JP/JS 14 (1C & 1D) Response/Clarification by JMRC on Pre-Bid Queries of Bidders

Figure 5.2: Tentative E1/SIP Connectivity for DIRECT LINE Network.

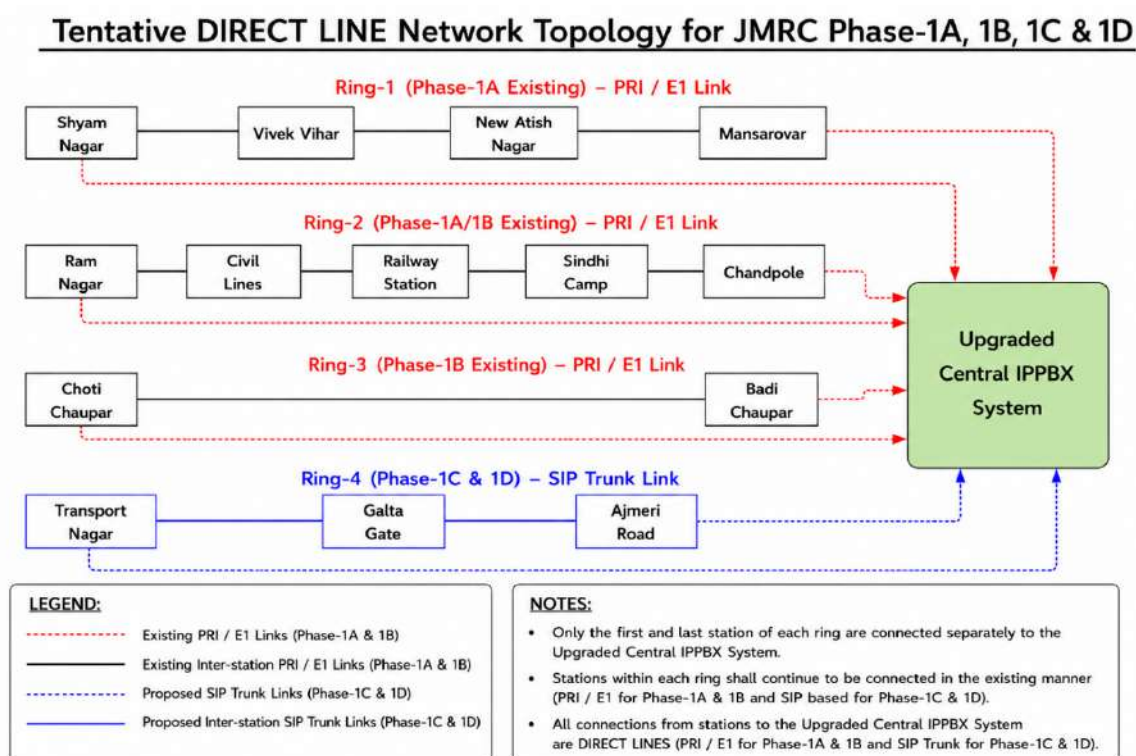
112	Chapter-9: PS Telephone System	1.1.4	401	Telephone Network for Phase-1A & 1B is formed by EPABXs installed for each phases (1A&1B) at OCC (which acts as the Main Node) and at each station. These nodes are interconnected in a ring through E1 links running over the FOTS Network backbone.	Please clarify the make/model and protocol capabilities of the existing EPABXs. Since the existing EPABXs are proprietary and may not support open-standard SIP, please clarify the proposed integration methodology with the new IP-based/open-SIP Telephone System?	Clause is self explanatory. Further, Bidder is advised to visit the Site for survey, with prior permission.
113	Chapter-9: PS Telephone System	1.1.4	401	These nodes are interconnected in a ring through E1 links	The Technical Specifications require an open-standard SIP-based Telephone System. Accordingly, please clarify whether the new Central Telephone System and Phase-1C & 1D Telephone Systems shall be interconnected using SIP over the available IP network, with adequate bandwidth provisioned based on the required number of simultaneous channels, instead of E1 connectivity?	Clause is self explanatory. Please refer Clause No. 5.1.1.4 (Figure-5.1 & 5.2).

114	Chapter-9: PS Telephone System	1.1.4(2)	401	the Existing OCC Central Telephone System shall be upgraded by replacing the existing Central EPABX of Phase-1A & 1B with a redundant IP-based Appliance Call Server (1+1) together with Gateway Architecture, Direct Line Consoles (DLCs), associated hardware, software, interface modules, licenses and accessories required for successful operation of the Telephone System	Since the existing OCC Central Telephone System is proprietary and may not support open-standard SIP, please clarify whether the requirement shall be treated as complete new IP-based Central Telephone System , comprising redundant Call Servers (1+1), Gateway Architecture, DLCs, licenses and associated accessories, rather than an upgradation of the existing system?	Clause is self explanatory. Please refer Clause No. 5.1.1.4 (Figure-5.1 & 5.2).
115	Chapter-9: PS Telephone System	1.1.4(2)	401	The Existing OCC Direct Line Consoles (DLCs) shall be upgraded or replaced, and the existing OCC Network Management System (NMS) of Phase-1A & 1B shall also be replaced by common NMS (1+1) as specified in these Particular Specifications.	Since the existing DLCs and NMS are proprietary systems and may not be compatible with the proposed open standard SIP-based architecture, please clarify whether complete replacement with new SIP-compatible DLCs and common NMS (1+1) shall be permitted?	Clause is self explanatory. Please refer Clause No. 5.1.1.4 (Figure-5.1 & 5.2).

Figure: 5.2.4.2: Tentative location & plan of tunnel Emergency Phones.

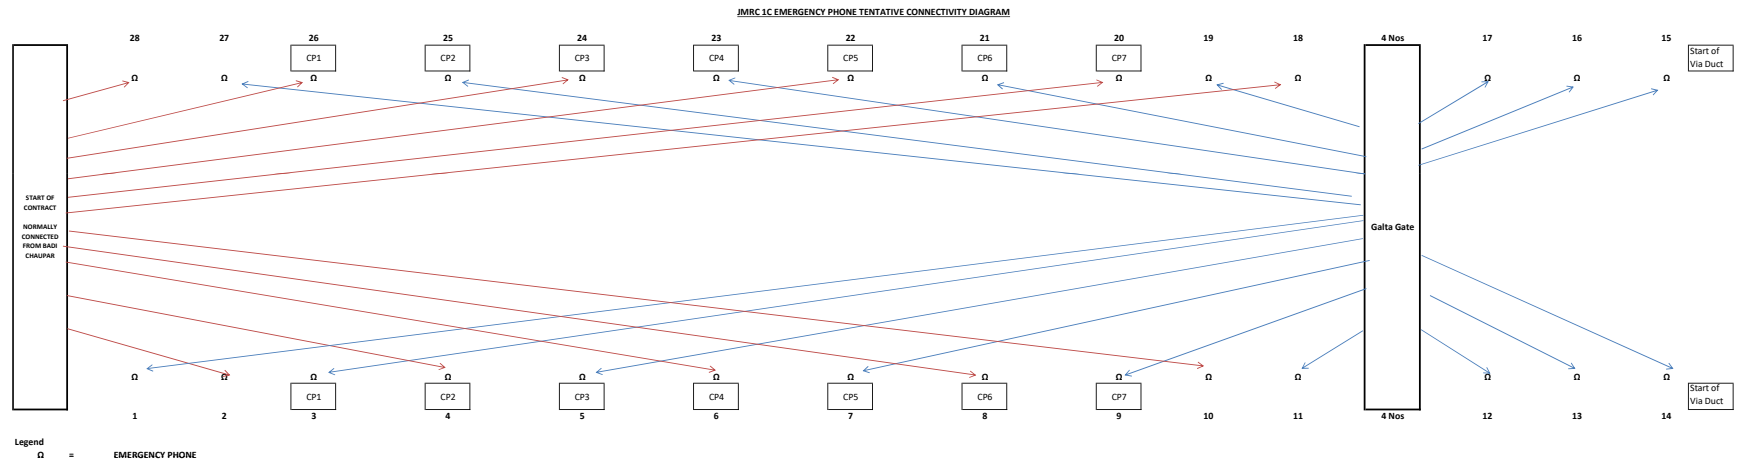
48.	31	PS (Chapter 8-Telephone)	5.2.3.1,5.2.3.2	Direct Line Telephones requirement updated	Replaced with 31R
49.	33	PS (Chapter 8-Telephone)	Figure:5.2.4.2	Figure corrected	Replaced with 33R
